Submission of the Trustees of PR Laird Trust by its Trustees **PHILLIP ROSS LAIRD** and Franklaw Trust Limited

This submission is made by the Trustees as the owners of lot 5 deposited plan 359488 in land title 242206, located at 29 Burbush Road, Rotokauri ("the submitter's property").

The specific parts of the Notice of Requirement in my submission relates to:

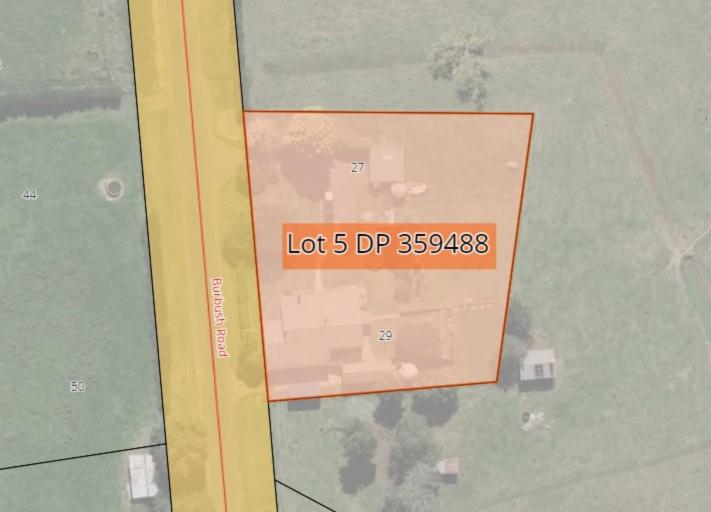
- 2. Effects on access to the submitter's property. The plans for the proposed road shows a development area that covers the main access driveway to the submitter's property.

- 5. Noise, dust and vibration effects on the dwelling on the submitter's property and surrounding residential site. The house was built some 60 years ago right on the boundary and in very close proximity to the existing road and even closer proximity to the proposed road. The property has a garden area that extends up to and partly into the road reserve.

- 6. Potential for flooding of the submitter's property. The property is low lying and already suffers from occasional flooding due to drains functioning poorly near to the submitter's

property, with a high-water table, the proposed road is likely to increase water run-off soakage and flooding from the proposed road land which already causes septic tank back flow on the submitter's property. This gives rise to health concerns.

- 10. Our submission is that the Council needs to rethink the location of the road, particularly to move it further from the submitter's property, and to rethink the methods that are to be used to minimise the impacts of the proposed road on the submitter's property during construction and operation of the road.

- 11. We seek the following decision from the Territorial Authority in relation to the Notice of Requirement:
 - (a) Relocate the road to be further away from the submitter's property.
